RESOLUTION NO. R6V-2011-(PROPOSED), AUTHORIZING THE EXECUTIVE OFFICER TO SIGN THE RECORD OF DECISION FOR OPERABLE UNIT 7, SITE 3, MAIN BASE INACTIVE LANDFILL, EDWARDS AIR FORCE BASE, KERN COUNTY

STAFF REPORT

RECORD OF DECISION

SITE 3 – MAIN BASE INACTIVE LANDFILL

Figure 4. Site 3 Contaminants Detected in Groundwater at Concentrations Greater Than Their Respective MCLs

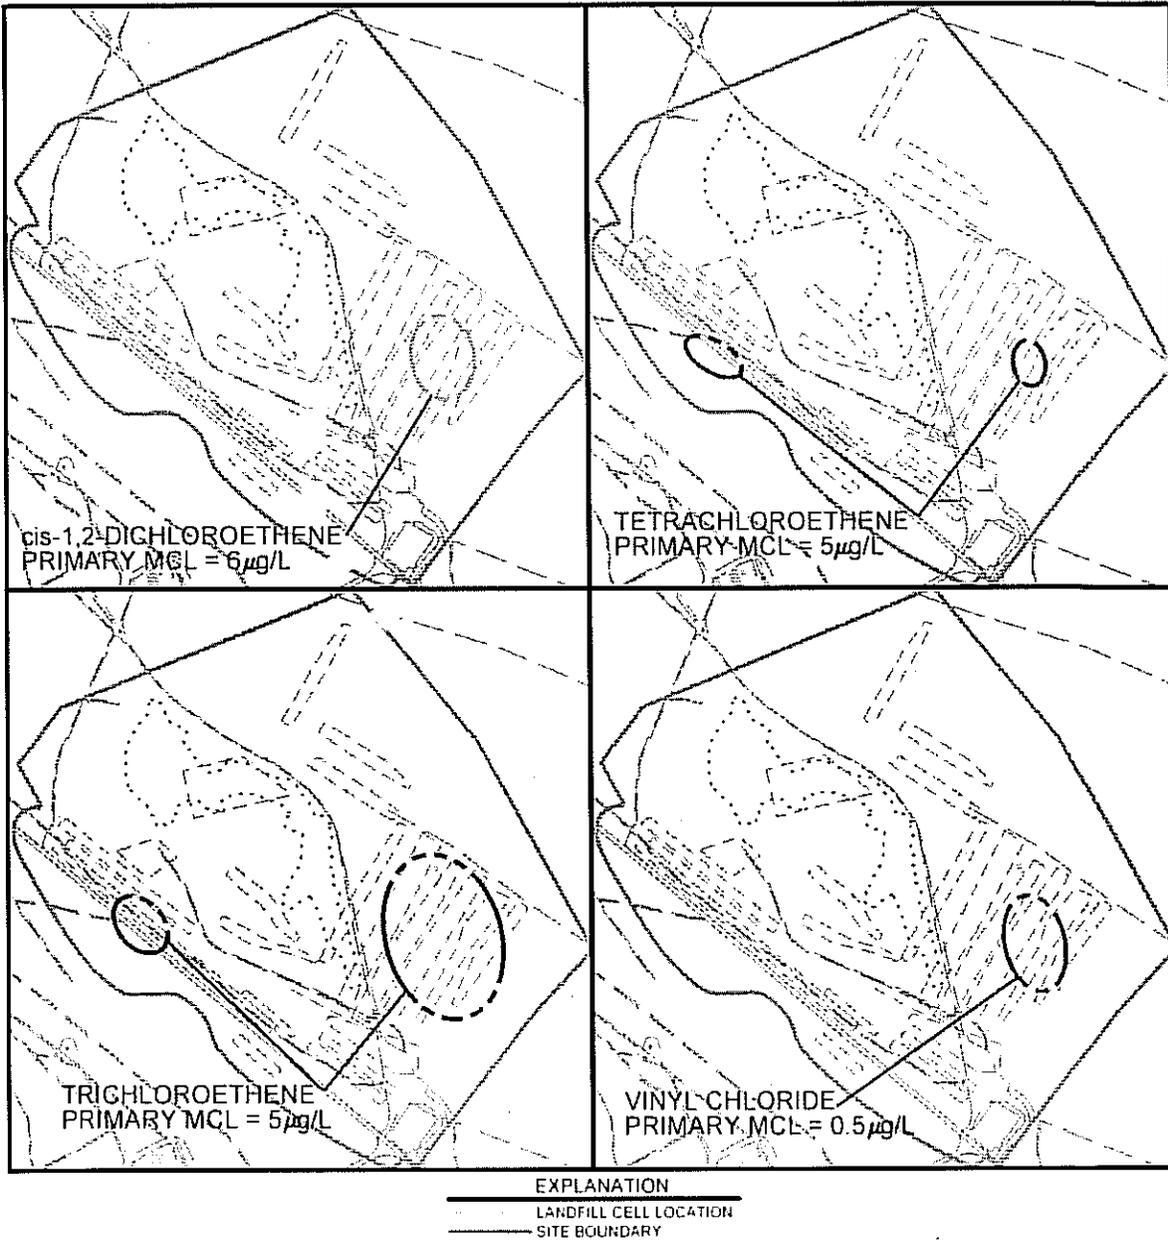
Figure 4 illustrates the areal extent of four of the contaminants of concern at concentrations greater than their respective MCLs. The organic contaminants PCE and TCE have been detected approximately 50 feet beyond the site boundary; nitrate has also been detected above background concentrations and its MCL near the southeast boundary of the landfill. Nitrate is not addressed in this ROD; however, the Air Force is addressing it separately in a Base-wide nitrate investigation. The estimated volume of groundwater impacted by organic contaminant concentrations above background (based on a 30-acre extent, 50-foot thick contaminated zone, and 5% fracture volume) is 75-acre feet.

Figure 5. Site 3 Conceptual Site Model

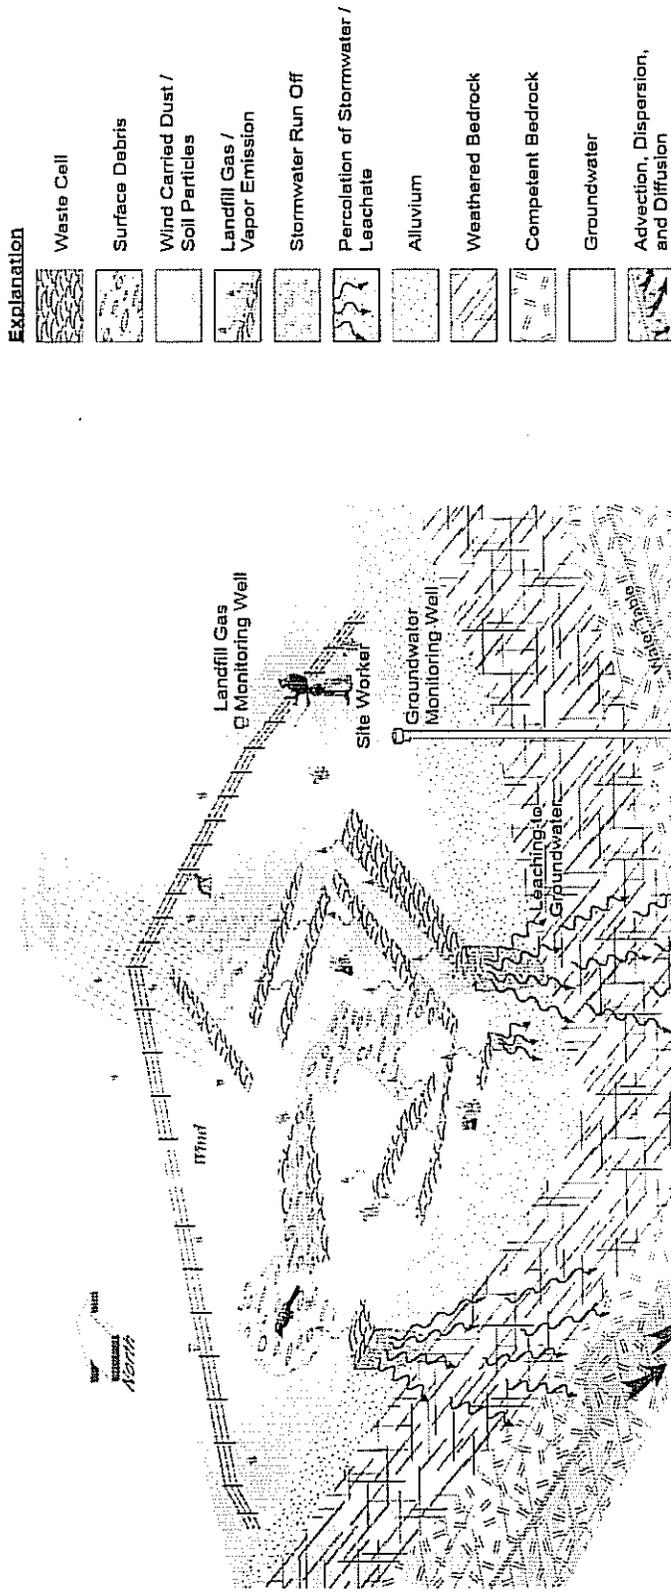
A groundwater mound has formed beneath the highest density of landfill cells toward the eastern portion of the site (see Figure 5, conceptual site model). This mound may be indicative of increased storm water infiltration through the disturbed surface cover and into the landfill cells. The disturbed material and landfilled materials would tend to collect, and be more transmissive to, storm water than the undisturbed native material surrounding the landfill cells.

Figure 6. Conceptual Drawing of Proposed Remedial Alternative

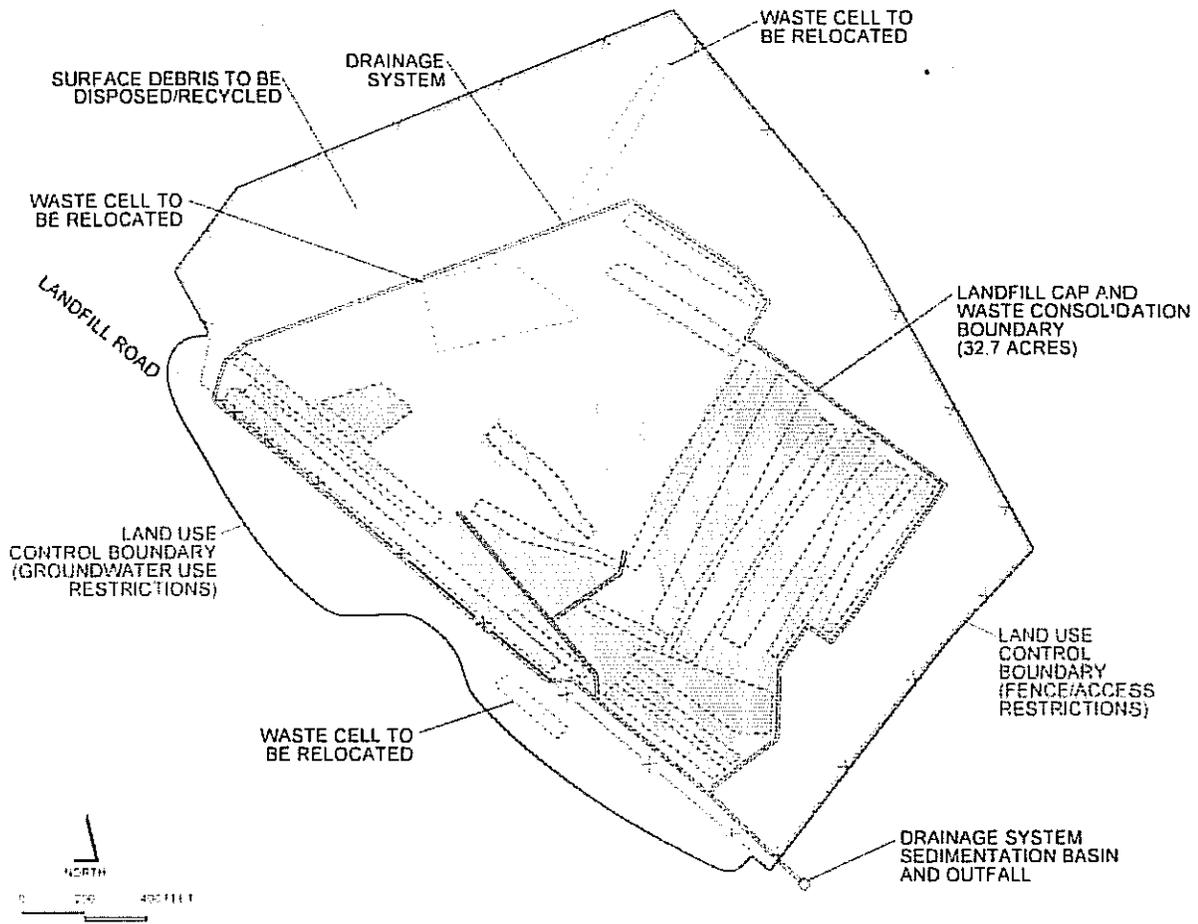
The main components and physical features of the Proposed Remedial Alternative are illustrated in Figure 6.
